**COMMONWEALTH OF KENTUCKY
BEFORE THE KENTUCKY STATE BOARD
ON ELECTRIC GENERATION AND TRANSMISSION SITING**

In the Matter of the Application of Turkey Creek)
Solar, LLC, for a Construction Certificate to Construct) Case No. 2020-00040
a Merchant Electric Generating Facility)

RESPONSE TO CONSULTANT’S REPORT

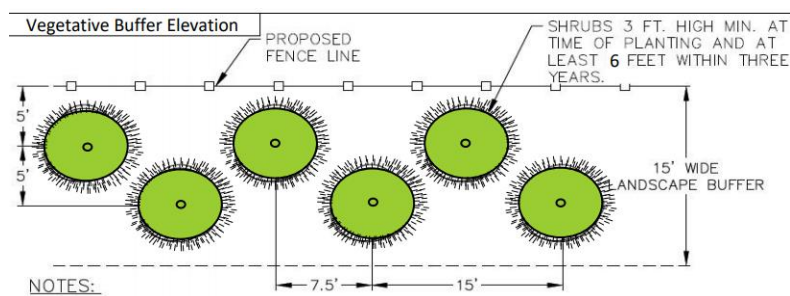
BBC had two recommended mitigation measures related to the Project’s compatibility with scenic surroundings. First, it recommended the “[p]lanting of native evergreen species as a visual buffer to mitigate viewshed impacts.”¹¹ It specifically stated that it “agrees with Turkey Creek’s proposal to plant ‘a vegetative buffer . . . if one does not already exist. This buffer will consist of two staggered rows of evergreen shrubs, approximately 15 feet wide and at least three feet in height at time of planting” around “sections of the Project that adjoin roadways and other properties.”¹²

Turkey Creek agrees with this first recommendation.¹³ With the collaboration of neighboring property owners,¹⁴ Turkey Creek proposed to have a vegetative buffer where one did not previously exist. Specifically, it proposes a buffer of “two staggered rows of evergreen shrubs, approximately 15 feet wide and at least three feet in height at time of planting.” A diagram of the proposed vegetative buffer was provided as Exhibit C to Turkey Creek’s Response to BBC’s Initial Request for Information and shown below.

- Turkey Creek will plant native evergreen species as a visual buffer to mitigate viewshed impacts. Plantings to primarily be in areas directly adjacent to the Project without existing vegetation. This buffer will consist of two staggered rows of evergreen shrubs, approximately 15 feet wide and at least three feet in height at time of planting around sections of the Project that adjoin roadways and other properties.
